**Our Case Number:** ABP-321776-25

**Re:** BusConnects Galway: Dublin Road Development  
R338 Dublin Road, Galway City.

## **GCCN Submission to An Bord Pleanála Bus Connects Galway: Dublin Road**

### The Junction of R338 Dublin Road and Renmore Road

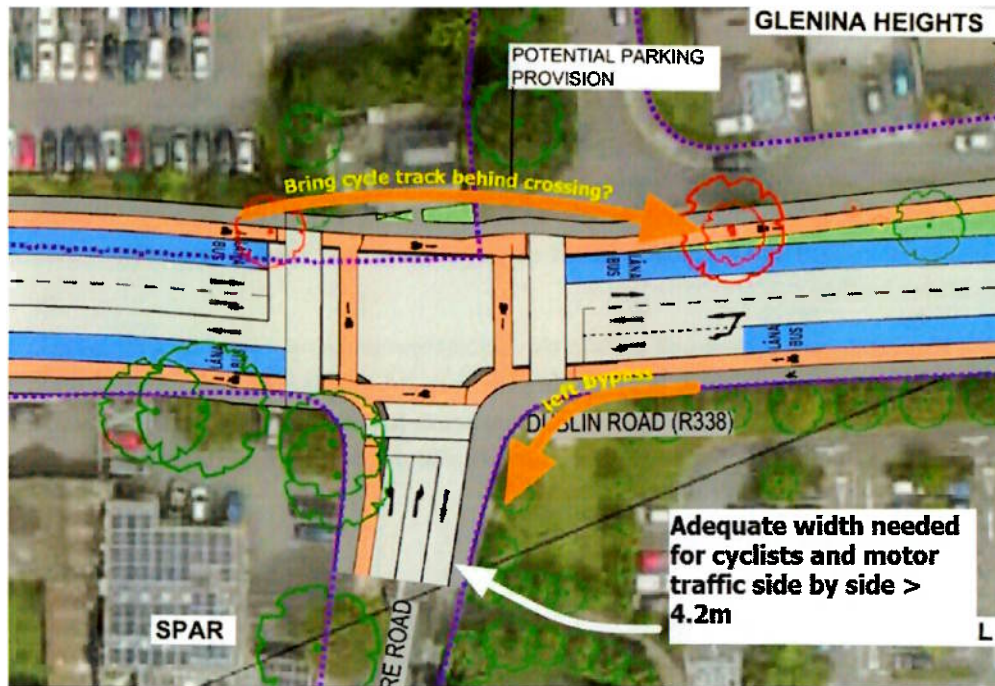
GCCN proposes that the house facing Duggan's shop on northside of the junction of junction of R338 Dublin Road and Renmore Road should be given a dedicated parking/driveway arrangement within

Glenina heights. Consideration should be given to swapping the footway and cycle track through the junction on the northside, so the cycle track by-passes the junction and pedestrian crossings. Alternatively, the cycle traffic on the crossing arm should have a green signal even when main arms are red, unless there are people on foot using the crossing. Adequate width is needed for cyclists entering Renmore Road from the R338. The junction arrangements should also allow cyclists to bypass the lights to turn left unless there are people on foot using the crossings. Renmore Road is a route to two schools. Adequate width is needed on the entry to Renmore Road so that cyclists do not get squeezed by motor traffic.

Consider bringing the outbound cycle track behind the pedestrian crossing - such as a floating bus stop/cyclops junction arrangement. There is a natural cycling route running north from this junction along the boundary of the Connacht Hotel and the recreational lands at Mervue. A formal cycling connection should be provided into Glenina Heights this will also provide for cyclists turning left into Micheal Collins Road.

### **Galway Crystal Junction:**

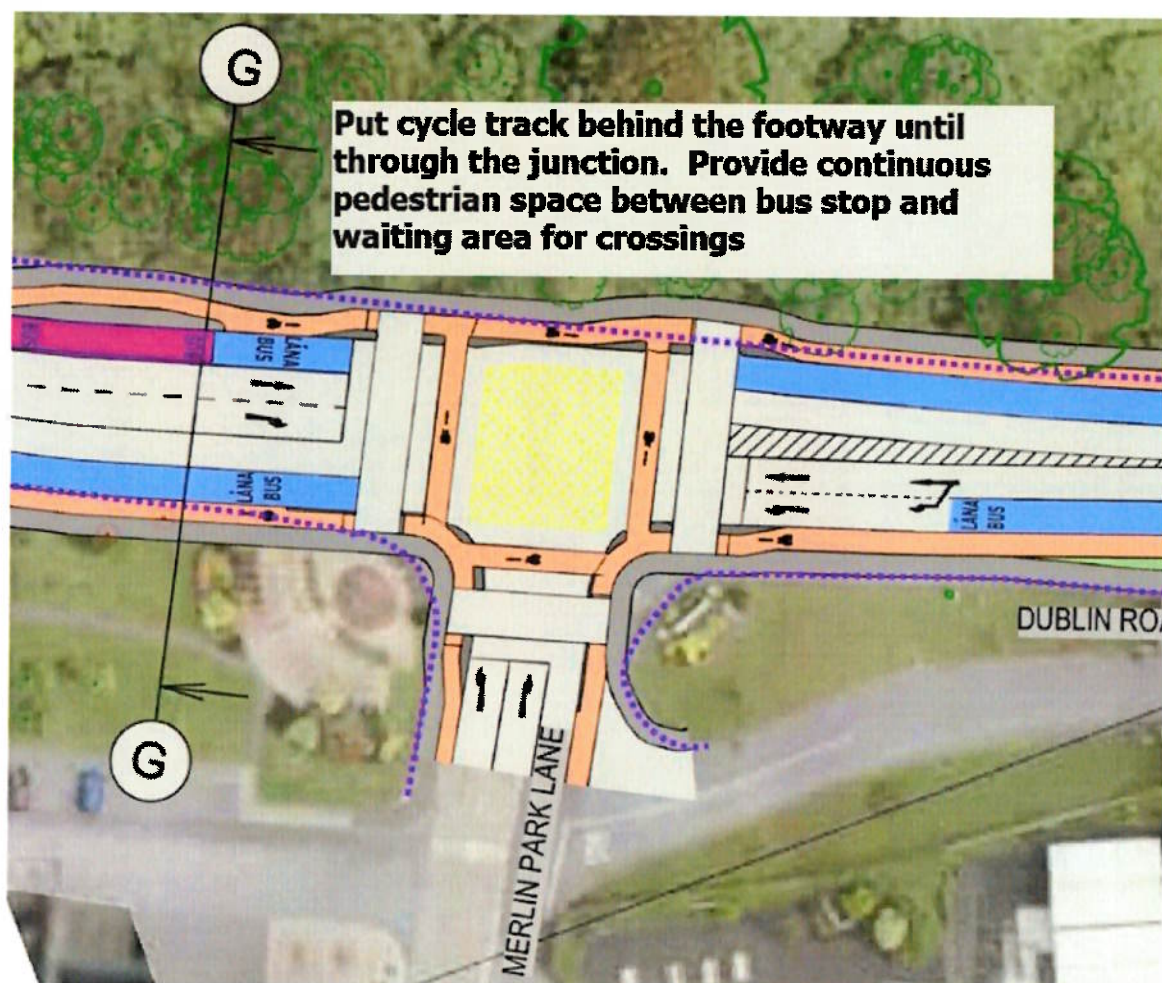
GCCN requests that consideration is given to the conversion of this junction to a Cyclops Junction.

Observation: The floating bus stop/island should be continued to, and through, the traffic lights. This means that the cycle track will be on the left of the pedestrian space at the junction. This will remove conflict with the eastbound cycle traffic who will be able to keep moving regardless of the traffic signals or pedestrian crossing state

The connection along the boundary of Galway Crystal through to Rosshill road should be formalised and upgraded. This is the natural desire line for cyclists coming from, or to, the coast road or Rosshill itself. Rosshill Road is a de facto cycling route for cycle traffic coming from Oranmore, please consider tying into the track at the end cutting through the trees.

### Junction of R338 Dublin Road and Coast Road

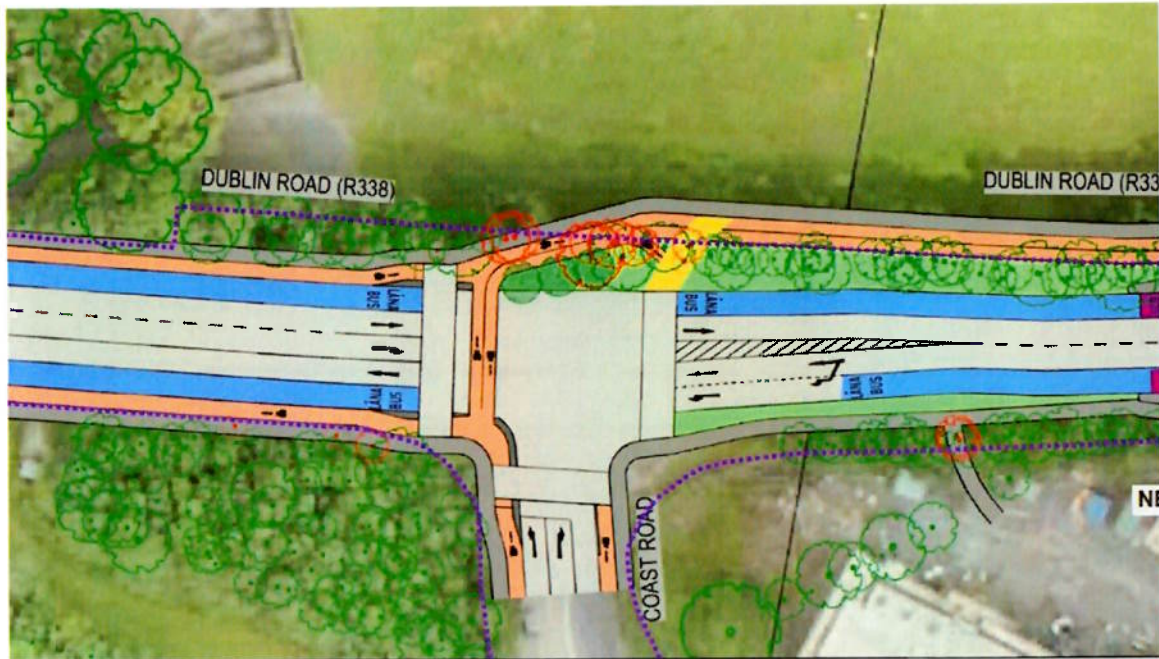
GCCN recommends that cycling bypasses for cyclists turning left should be available on all arms. (Land does not seem to be an issue here). The design of the junction is not intuitive, and it is not clear how cyclists are supposed to access the coast road. GCCN requests that consideration be given to converting this junction to a Cyclops junction.

#### **Castlegar GAA Pitch**

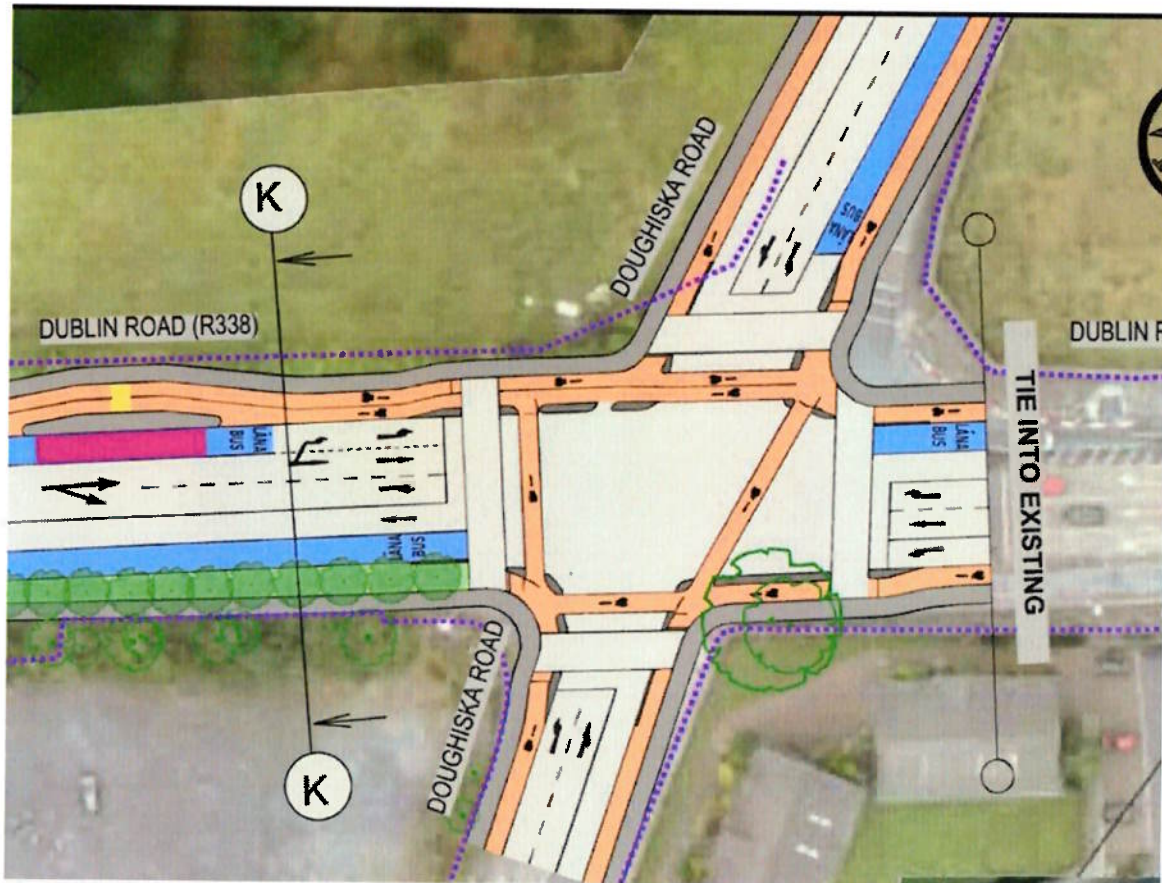
GCCN observes in the plans that cycle facilities are only shown on the north side of the road. In the plan the footway on the south side of the road is marked as "Shared Pedestrian Cycle path". The cross section shows this feature as being 1.8m. GCCN recommends that 1.8m is inadequate for a shared footway particularly for wheelchair users. This should be widened to 3m.<sup>4</sup>
